December 11, 2023

Genevieve Johnson  
Reclamation 2007 Interim Guidelines SEIS Project Manager  
Upper Colorado Region  
125 South State Street, Suite 8100  
Salt Lake City, Utah 84138  
[CRInterimops@usbr.gov](mailto:CRInterimops@usbr.gov)

RE: U.S. Bureau of Reclamation's Revised Draft Supplemental Environmental Impact Statement for Near-term Colorado River Operations dated October 2023 (88 Fed. Reg. 73840)

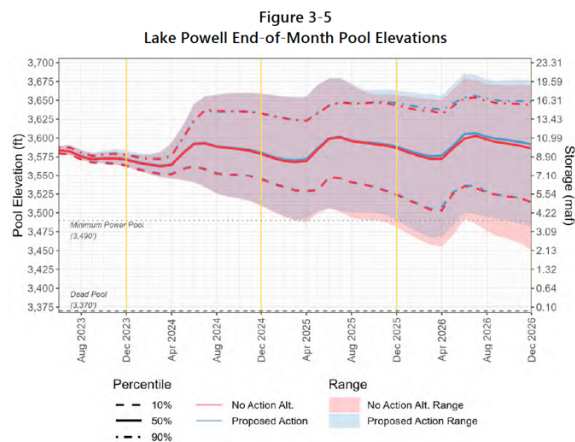
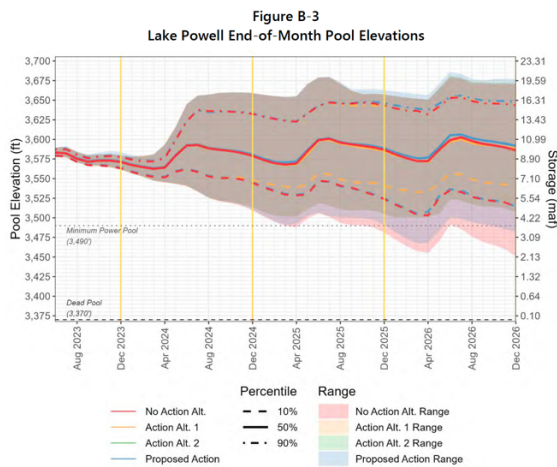
In **Figure 3-5** (Lake Powell) and **Figure 3-8** (Lake Mead) of the Revised Draft SEIS, Reclamation analyzes the No Action Alternative against the Lower Basin Proposal/Propose Action based on the new June 2023 hydrology. While the June 2023 hydrology significantly reduces the risk of the No

Specifically for Lake Powell, Reclamation found 8 percent of traces reaching critical elevations through 2026 for the No Action Alternative and 4 percent of traces for the Lower Basin Proposal.<sup>29</sup> However, what is particularly interesting is Reclamation’s analysis in Appendix B of the Revised Draft SEIS, which looks at not just the No Action and Lower Basin Plan, but also includes an analysis of Reclamation’s Alternatives 1 and 2 under the June 2023 hydrology. The gray cloud in Figure B-3, *Lake Powell End-of-Month Pool Elevations* (left), shows that the amount of conservation in Alternatives 1 and 2 provides a benefit to reservoir elevations beyond the selected alternatives that is not insignificant. A side-by-side comparison of Lake Powell End-of-Month Pool Elevations modeled in the Revised Draft SEIS are shown in **Figure B-3** (left) and **Figure 3-5** (right) below:

It is clear from these graphs that better outcomes, at least for Lake Powell, occur under Alternatives 1 and 2. Appendix B of the Revised Draft SEIS<sup>30</sup> provides

The question remains why the cloud for the Proposed Action in **Figure 3-5** falls below the minimum power pool critical elevation in 2025 and 2026 for certain traces despite the protection mechanism of 3,500 feet being included in that Alternative. We assume that this occurs because of the commitment to maintain the minimum flows required in LTEMP, but a clearer explanation of this is needed in the Revised Draft SEIS. If this is the case, then the need for additional conservation to be added to the alternatives or another policy revision may be needed to protect against Lake Powell reaching minimum power pool and meeting the purpose and need of the action.

**Figure 4. Comparison of 6-Basin States Alternative to Proposed and No Action Alternatives**

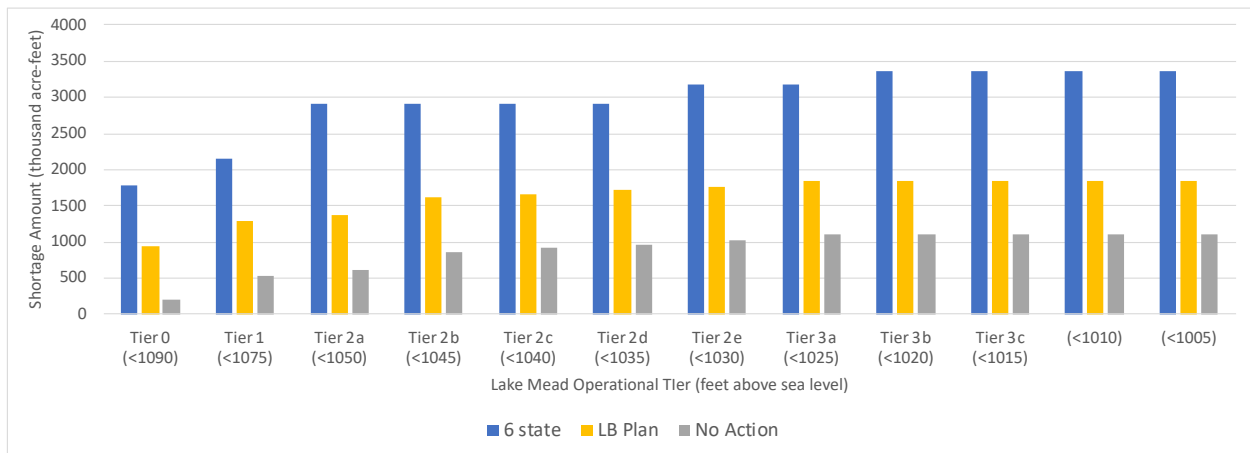
On January 31, 2023, the 6-basin states (Arizona, Colorado, Nevada, New Mexico, Utah, and Wyoming) submitted an alternative to Reclamation “that apportions among all contractors reductions to account for water evaporation, seepage, and system losses.”<sup>41</sup> Reclamation also received scoping comments that were in favor of such an alternative, including from the Trust.<sup>42</sup> Reclamation refused to carry it forward in both the April Draft SEIS and the Revised Draft SEIS based on the reasoning that “the Proposed Action contemplates conservation amounts similar to those that would be assessed based on evaporation, seepage, and system loss calculations in the proposals received.”<sup>43</sup> In fact, the amount of water conservation proposed by the 6-States Plan significantly outpaces the conservation proposed in the proposed action. This is easily seen in the figure below.

More specifically, the 6-State Plan proposed shortage amounts that exceed those in the Lower Basin Plan by more than 800,000 acre-feet (at higher elevations, Tier 0 < 1090 feet) and by 1.5 maf (at lower elevations, Tier 3b < 1020). Reclamation may have had more solid ground to stand on when it made that statement in the April Draft SEIS because that analysis also included Alternatives 1 and 2, which have significantly more water conservation than the proposed action. The fact is the Lower Basin Plan and the No Action Alternative do not contemplate nor analyze fully similar conservation amounts in this Revised Draft SEIS. Thus, Reclamation cannot justify eliminating this alternative from consideration in the Revised Draft SEIS unless it were to consider another alternative that assessed similar demand reductions and policy amounts like Reclamation’s Alternatives 1 and 2.

**Figure 5. Comparison of California’s Alternative to Proposed and No Action Alternatives**

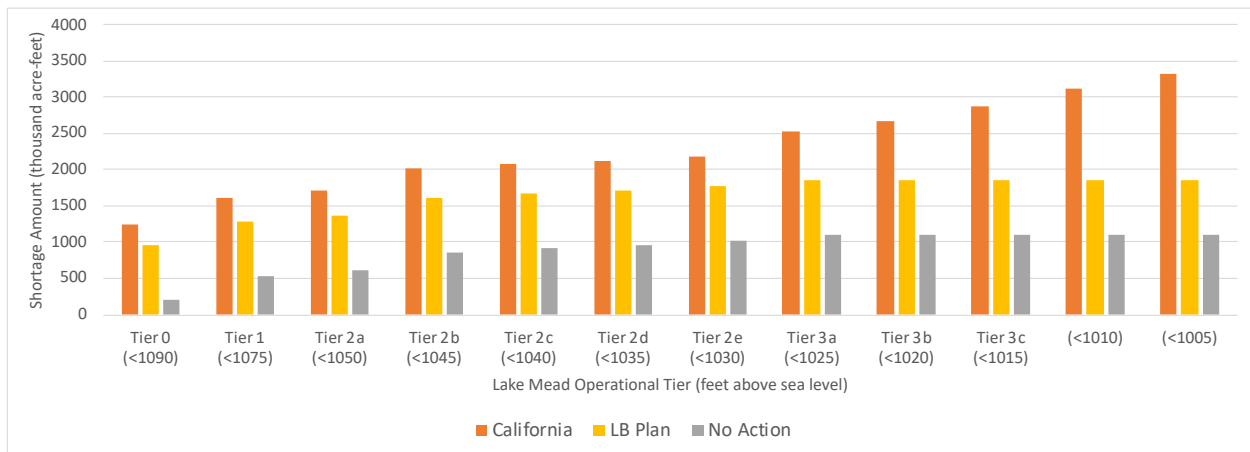
On January 31, 2023, California proposed an alternative to be analyzed in the April Draft SEIS. This alternative was not even mentioned as “considered but eliminated from detailed analysis” in either Section 2.9 of the April Draft SEIS or Section 2.8 in the Revised Draft SEIS.<sup>44</sup> The California Plan, however, was incorporated into Appendix B of the April Draft SEIS and it was run through Reclamation’s model based on the September 2022 hydrology.<sup>45</sup> The proposal offered revisions to the 2007 Interim Guidelines related to upper basin demand management, Glen Canyon Dam operations, and lower basin demand reductions.<sup>46</sup> California’s proposed lower basin water use reductions are as follows:

The shortages proposed are clearly more substantial than those incorporated into the Lower Basin Plan/Proposed Action. Reclamation failed to provide its reasoning for why this plan was not even included in the “considered but eliminated” category or why it ultimately was not analyzed or carried forward into the Revised Draft SEIS. We believe this alternative contains policy revisions that Reclamation could and should have considered and analyzed in the Revised Draft SEIS.

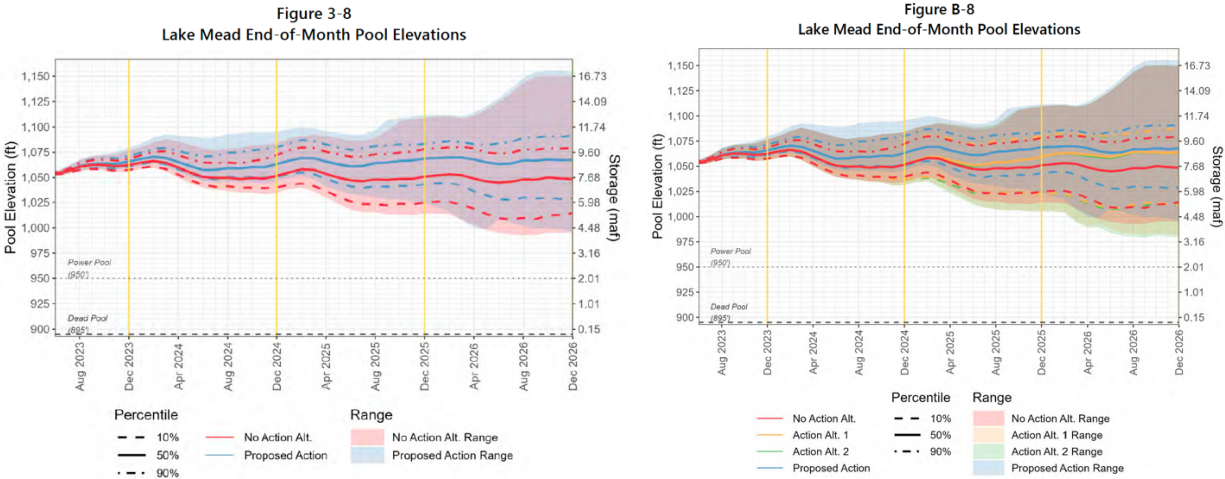
Figure 3-8 from the Revised Draft SEIS<sup>56</sup> (left) and Figure B-8 from Appendix B to the Revised Draft SEIS<sup>57</sup> (right) show modeled reservoir elevations at Lake Mead.

Figure 3-8 shows that Lake Mead elevations stay well above (nearly 50 feet) above minimum power pool (elevation 950 feet) under the No Action and Proposed Action. Figure B-8 shows the clouds for traces for Alternatives 1 and 2 reaching lower elevations approaching elevation 975 feet in 2026. “Action Alternatives 1 and 2 have the lowest modeled elevations at 982 feet and 980 feet, respectively, while the No Action Alternative and Proposed Action end 2026 approximately 13 to 16 feet higher at around 995 feet and 996 feet, respectively.”<sup>58</sup> However, it should be noted that 980 feet (the lowest elevation reached) is still 30 feet over minimum power pool at Lake Mead. The buffer at Lake Powell (3,500 feet) is only 10 feet above the minimum power pool elevation of 3,490 feet. If this comparison were apples to apples, we’d be looking at a Lake Powell protection level of 3,515 feet to Lake Mead’s 1,000 feet or Lake Powell 3,500 feet to Lake Meads 950 feet. The reason for this difference is not stated or explained in the Revised Draft SEIS.

Figure B-9 in Reclamation’s analysis uses Lake Mead elevation 1,020 feet to analyze percentages of traces below critical reservoir elevations.<sup>59</sup> Reclamation notes that “[a]n elevation of 1,020 feet was

**Figure 6. Impact of Mid-Year Adjustment on 8.23 maf Release Reduced to 6.0 maf**

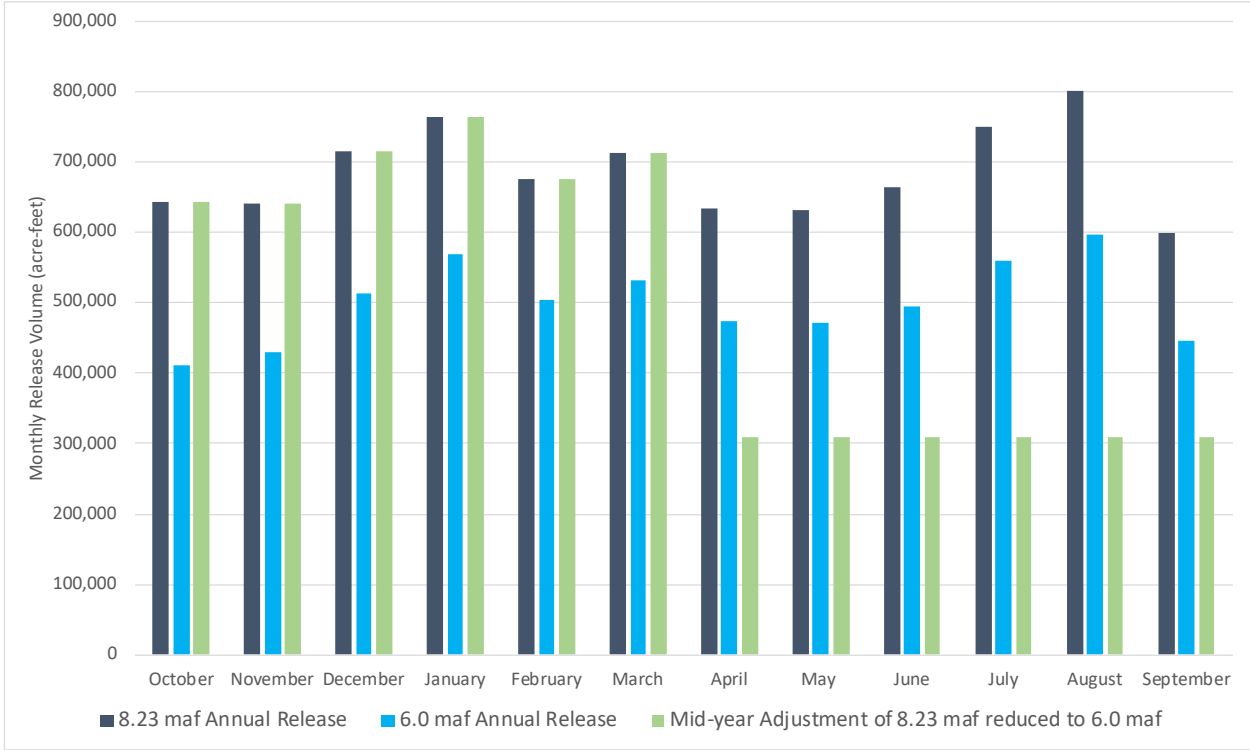
We are very concerned, however, about how the monthly distributions of water into the Colorado River below Glen Canyon Dam would be affected if the adjustment to 6.0 maf is made mid-year as allowed by the proposed action.<sup>75</sup> We are also concerned that LTEMP daily minimum flows may not be met as the commitments around meeting the flows are not clearly set forth in the Revised Draft SEIS. See Section I.D.3, below. This is especially concerning when Glen Canyon Dam is operating in the Mid-Elevation Release Tier and Lake Mead is below elevation 1,025 feet, where an 8.23 maf release is contemplated.

For example, the Trust’s **Figure 6** attempts to play out this scenario where an 8.23 maf release year is reduced to 6.0 maf mid-year. The dark blue bars in the figure represent releases under an 8.23 maf year using the monthly distributions set under LTEMP (see Table 3-5, above). The turquoise bars show a 6.0 maf release based on the sample monthly LTEMP distributions (see Table 3-5, above). The green bars show a combination of these two scenarios, where the mid-year review cuts releases for the last 6 months of the year.

Thus, for the first 6-months of the water year (October through March), Glen Canyon Dam would release 4.151 maf under the 8.23 maf schedule. If at that point the April 1 forecast (mid-year review)

**Figure 7. Impact of Mid-Year Adjustment on LTEMP Daily Minimums under 8.23 to 6.0 maf**

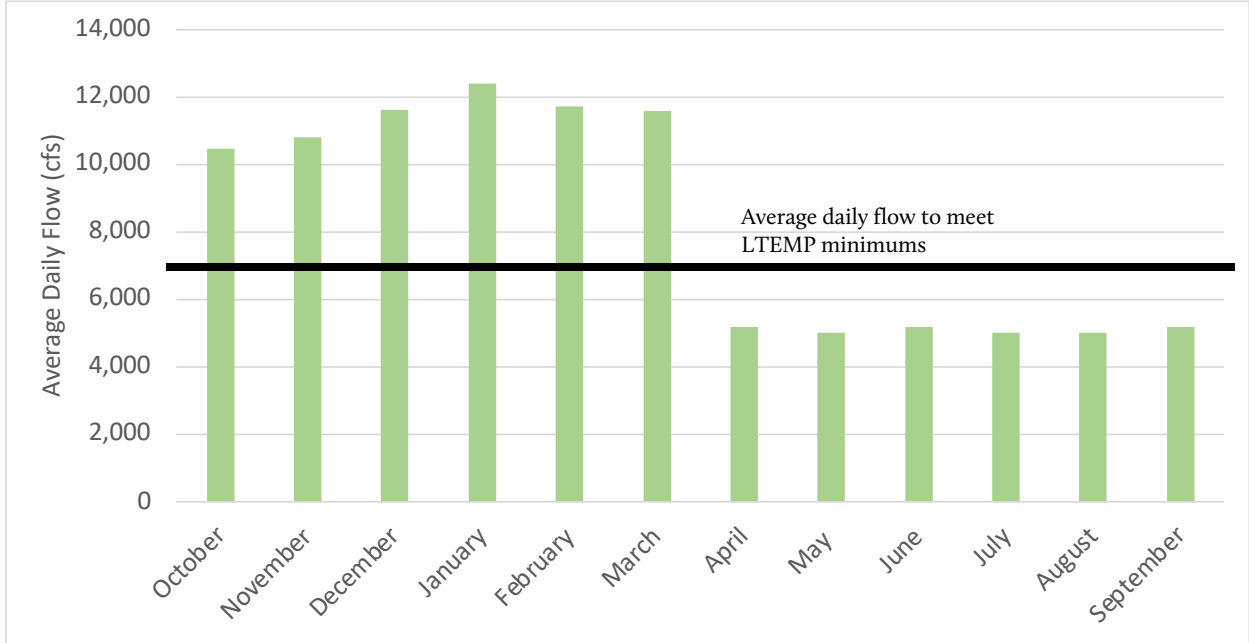
The Trust’s **Figure 7** shows average daily flows in cubic feet per second (in green) for each month during the water year. The black horizontal bar roughly shows the average daily flow needed (6,521 cfs) to maintain LTEMP minimum flows under the 8.23 to 6.0 maf mid-year adjustment scenario described above.

Despite this example of how the mid-year flow reductions combined with the 3,500 feet elevation protection at Lake Powell may operate to impact resources downstream of Glen Canyon Dam, it is incredibly unclear in the Revised Draft SEIS exactly how the LTEMP minimum flows or reservoir elevations will be prioritized under the revised guidelines. See Section I.D.3, below. Reclamation needs to develop guidance for how these competing goals should play out under the revised guidelines.

**Figure 3-35**  
**Box Plots Showing the Number of Days with an Average Glen Canyon Dam Release Temperature over 16°C (60.8°F) for All CRMMS Traces and Each Alternative for Operating Years 2023–2026\***

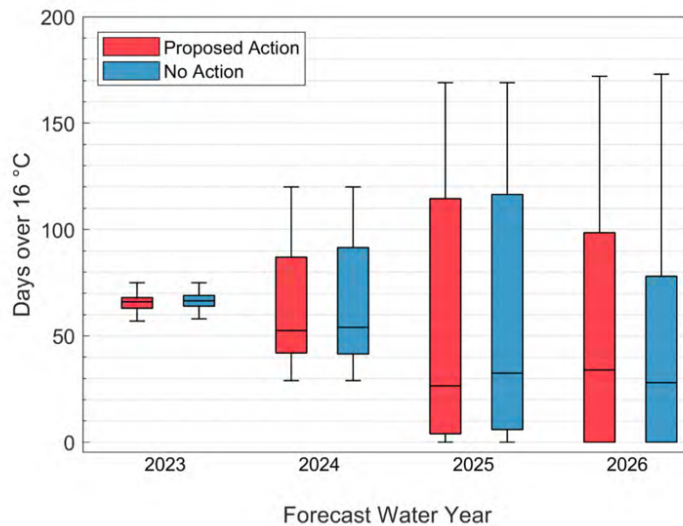
Reservoir elevations and where water is released (through the penstocks or the river outlet works) is “a key determinant” of release temperatures from Glen Canyon Dam.<sup>82</sup> Reclamation’s modeling of the selected alternatives indicates that at the lower end of the modeled traces, Lake Powell could fall below minimum power pool (elevation 3,490 feet) as soon as 2025 and those reservoir elevations may hover around that “protection level” for the remainder of the interim period.<sup>83</sup> **Figure 3-35** shows the number of days with average release temperatures over 16 degrees C under the selected alternatives.

Given that smallmouth bass are already reproducing in Marble and Grand Canyons, these temperatures will further exacerbate the likelihood that the establishment will continue. Without
